A/FLN/22

**Section 16 Planning Application for
Temporary Shop and Services, Place of Entertainment,
Place of Recreation, Sports or Culture (Barbecue Site) and
Public Vehicle Park (excluding container vehicle) for a Period of 3 Years
at Lots Nos. 517 RP, 518 RP, 521 RP, 522, 523 RP, 524 RP, 525, 526,
527 RP, 532 RP (Portion), 533 RP (Portion), 534 RP (Portion),
539 (Portion), 540 (Portion), 541 (Portion), 542 (Portion), 543 (Portion),
544, 545, 547 (Portion), 548 (Portion), 551 (Portion), 552 and 553,
and Adjoining Government Land in D.D. 51
Fu Tei Au and Shek Wu San Tsuen, Sheung Shui, North, New Territories**

Section 16 Planning Application No. A/FLN/22
Temporary Shop and Services, Place of Entertainment,
Place of Recreation, Sports or Culture (Barbecue Site) and
Public Vehicle Park (excluding container vehicle) for a Period of 3 Years
at Lots Nos. 517 RP, 518 RP, 521 RP, 522, 523 RP, 524 RP, 525, 526,
527 RP, 532 RP (Portion), 533 RP (Portion), 534 RP (Portion),
539 (Portion), 540 (Portion), 541 (Portion), 542 (Portion), 543 (Portion),
544, 545, 547 (Portion), 548 (Portion), 551 (Portion), 552 and 553,
and Adjoining Government Land in D.D. 51
Fu Tei Au and Shek Wu San Tsuen, Sh

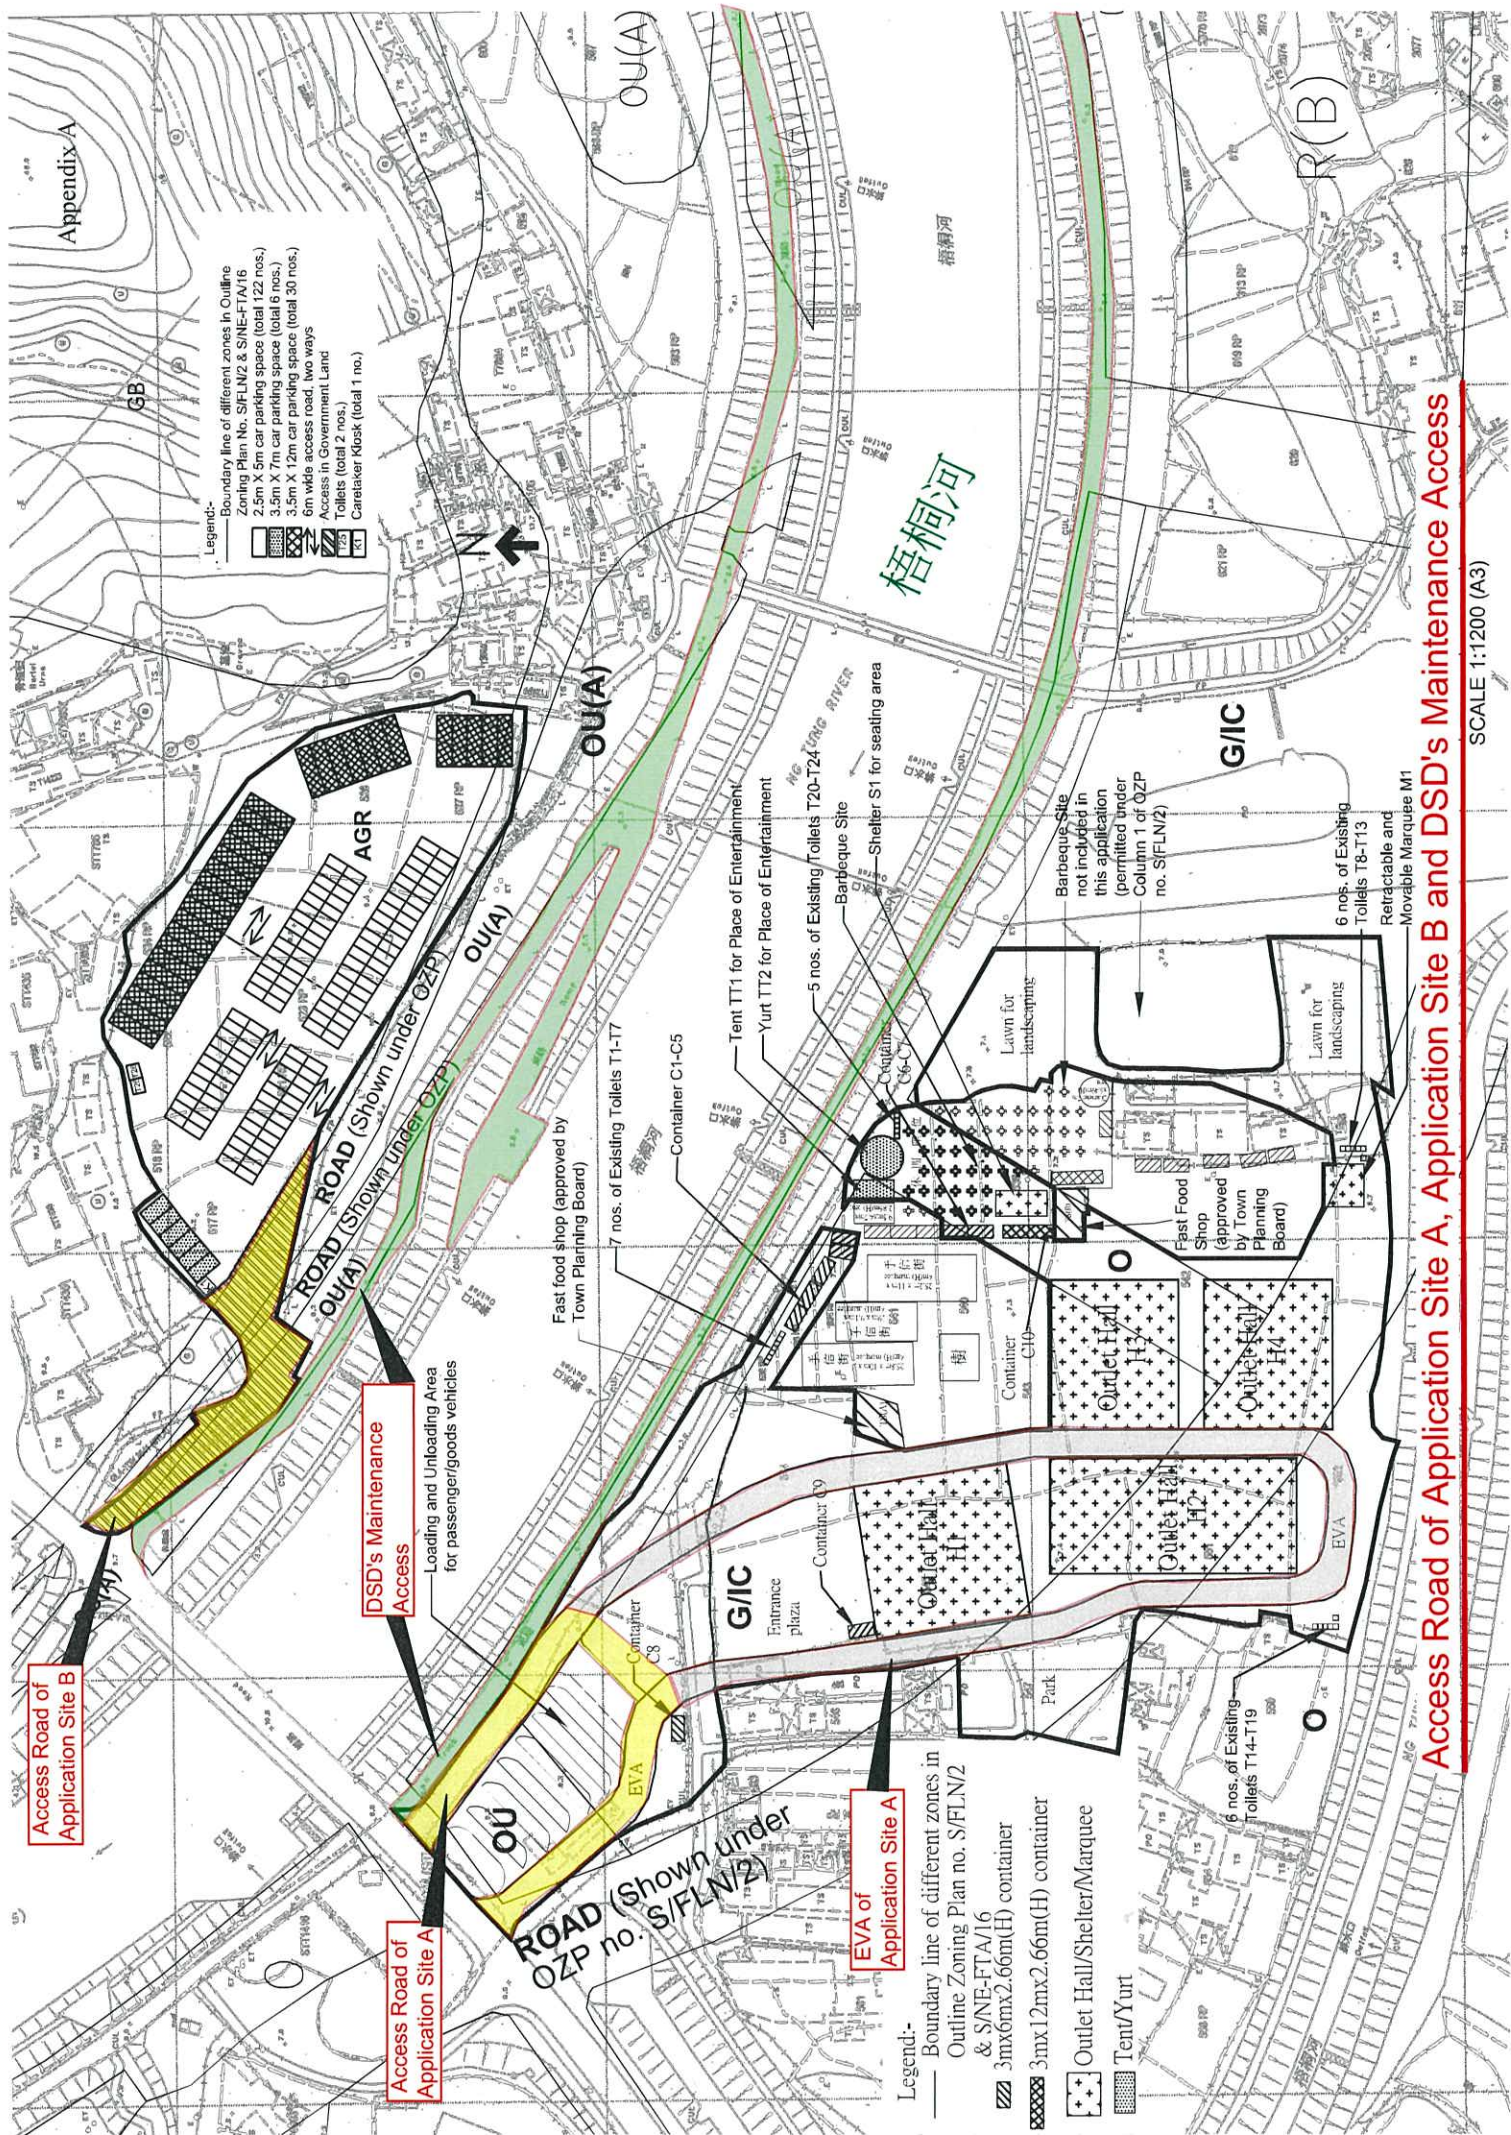
2.	From: DSD (Mr Henry YU, Tel: 2300 1407 Email: wcyu@dsd.gov.hk)	
(a)	The applicant should confirm that no DSD's existing maintenance access for the Ng Tung River would be affected by the proposed development.	The Applicants hereby confirm that no DSD's maintenance access for the Ng Tung River would be affected by the proposed development. This is because the accesses of Application Sites A and B are both independent of the DSD's maintenance accesses on both sides of Ng Tung River. The attached plan Appendix A refers.

LAYOUT PLAN OF SITE A

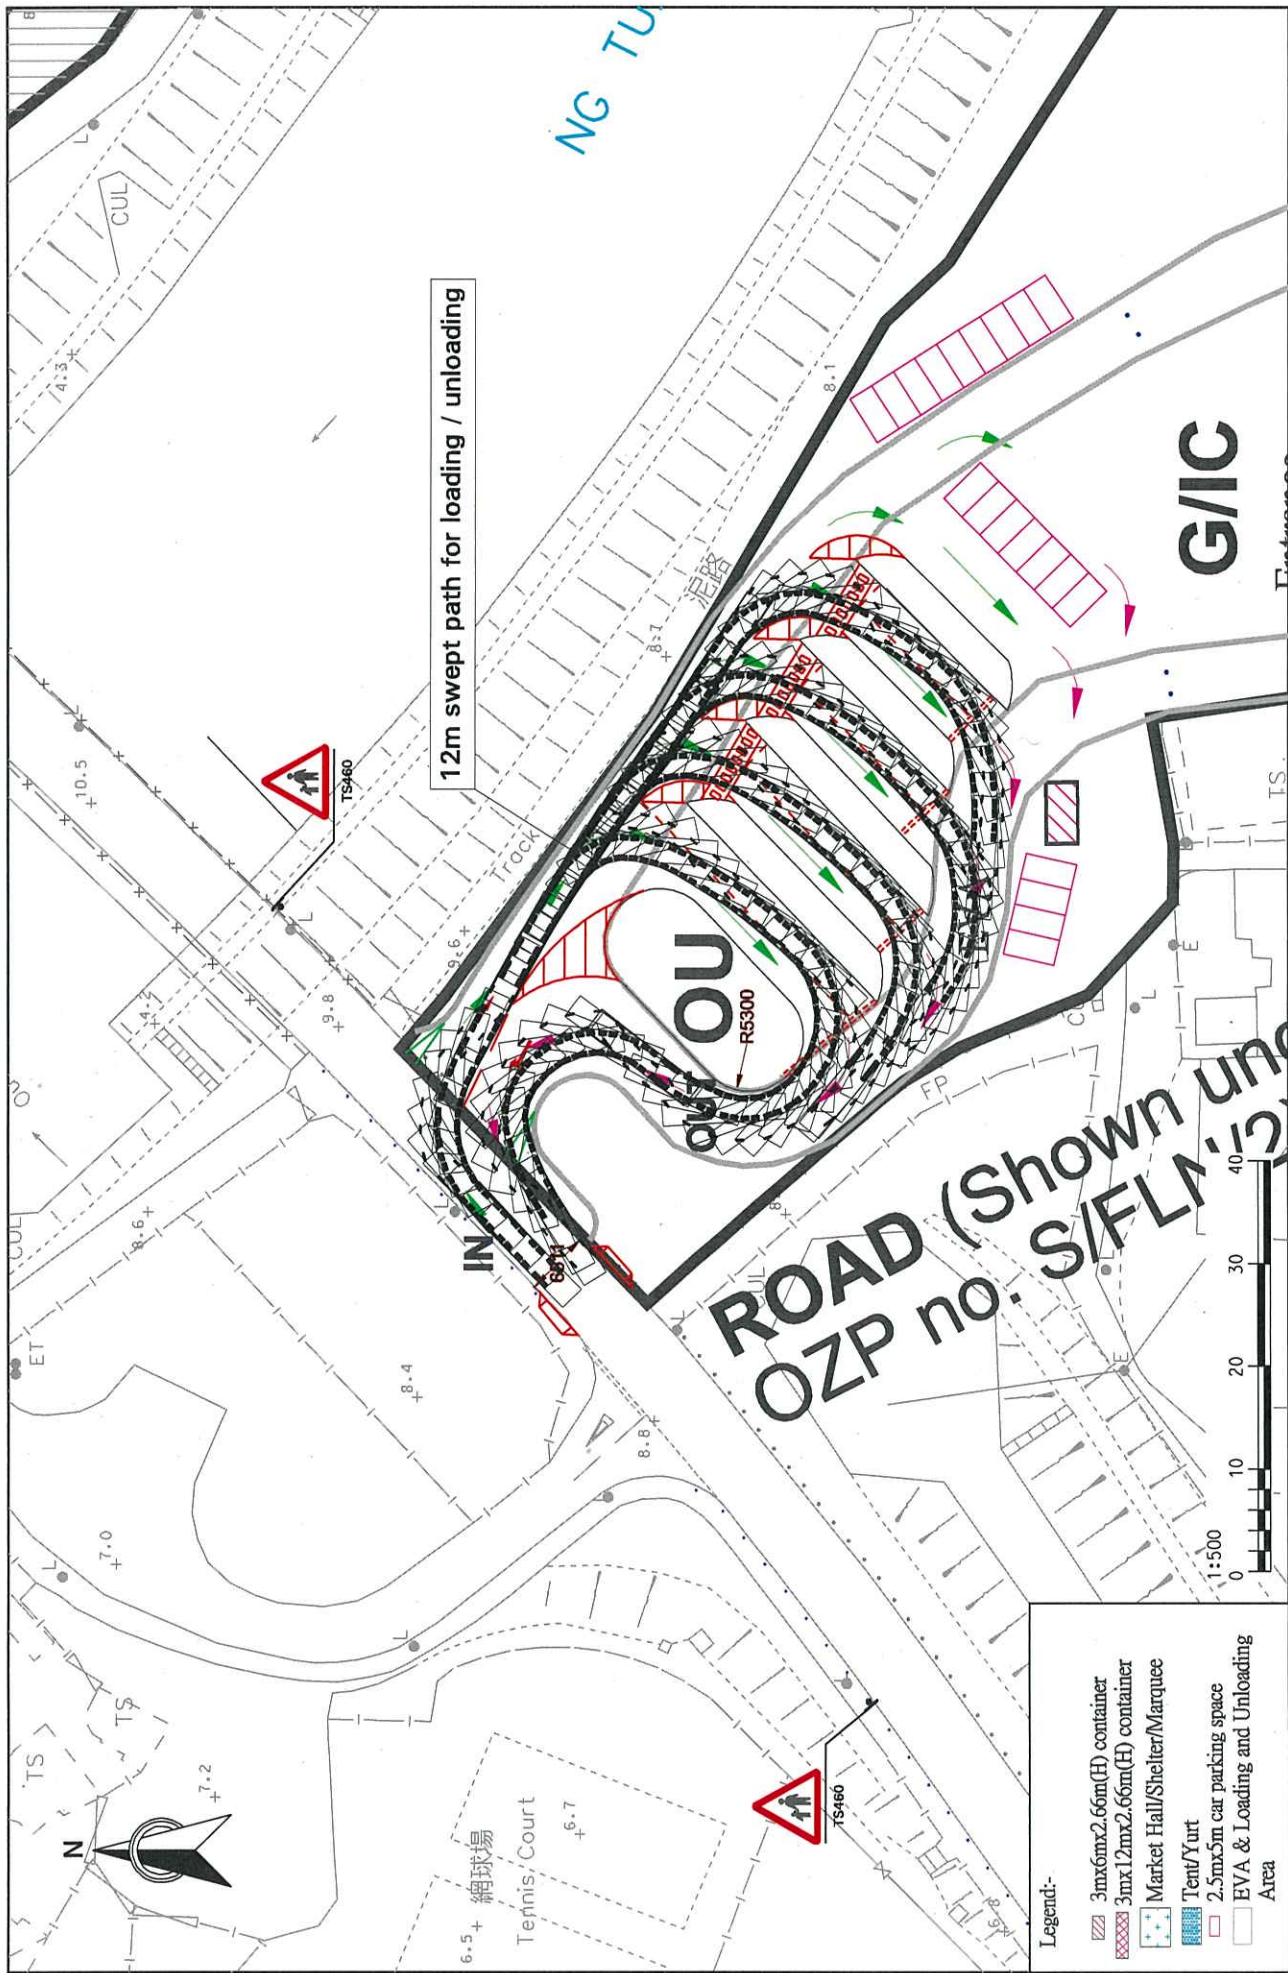
20)	On Figure 2-1, Layout Plan of Site A, a road marked as EVA is connecting the entrance to the site to the market halls. Please advise whether the EVA will serve as internal vehicular access road or not. Please confirm that this access road-cum-EVA shall be designed and constructed to	The EVA will not serve as internal vehicular access. It will be opened for emergency vehicle only. Temporary barrier such as bollard will be erected to delineate the EVA from the vehicular access road.
